PN 83042-1: Mandatory Condensate “Y” Upgrade

NY Thermal Inc. has determined that the condensate Y located within the boiler may prematurely deteriorate, in applications where condensate acidity levels are unexplainably twenty times higher than normal. As NY Thermal Inc. cannot predict the occurrence of the anomaly, all Y fittings must be replaced immediately.

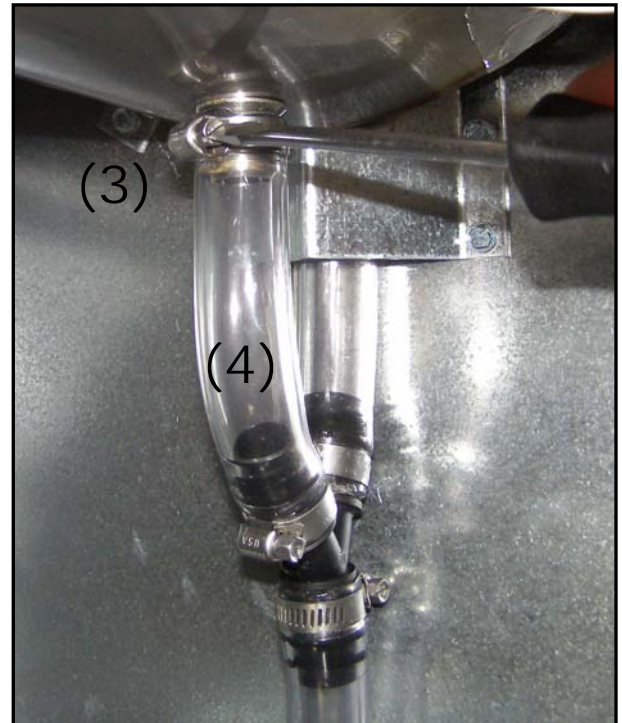
- 1) Identify the color of the Condensate Y; if it is black replace it.

CAUTION: Do not cut or pull on this tube. It must remain connected to the boiler.

If the tube is disconnected from the back of the boiler, the boiler will need to be removed to repair.

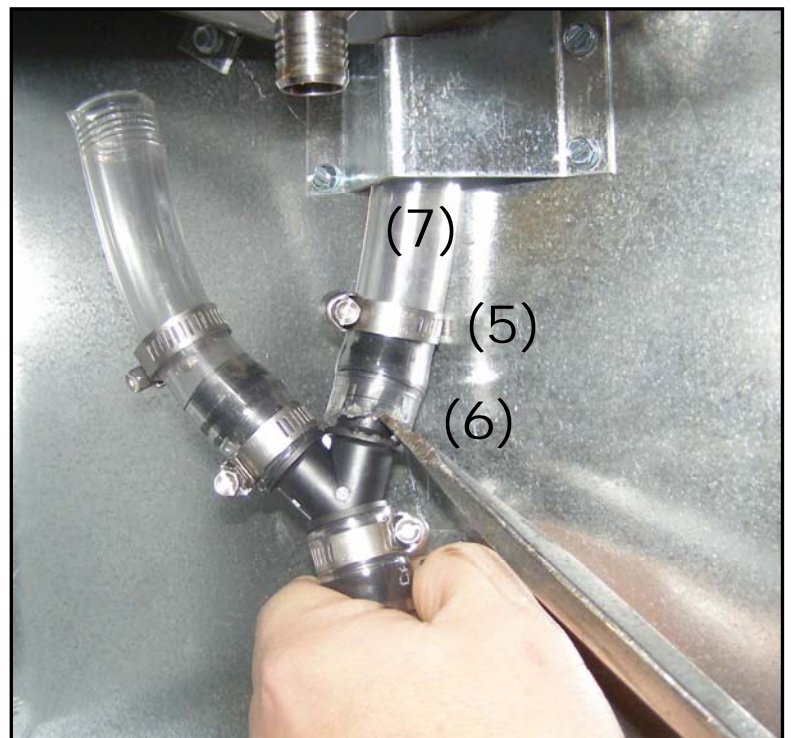
- 6) Very carefully, using a wide tipped flat screwdriver pry the tube off the "Y" connector.

- 7) **DO NOT PULL THE TUBING DOWN, AS IT MIGHT DISCONNECT FROM THE BACK.**
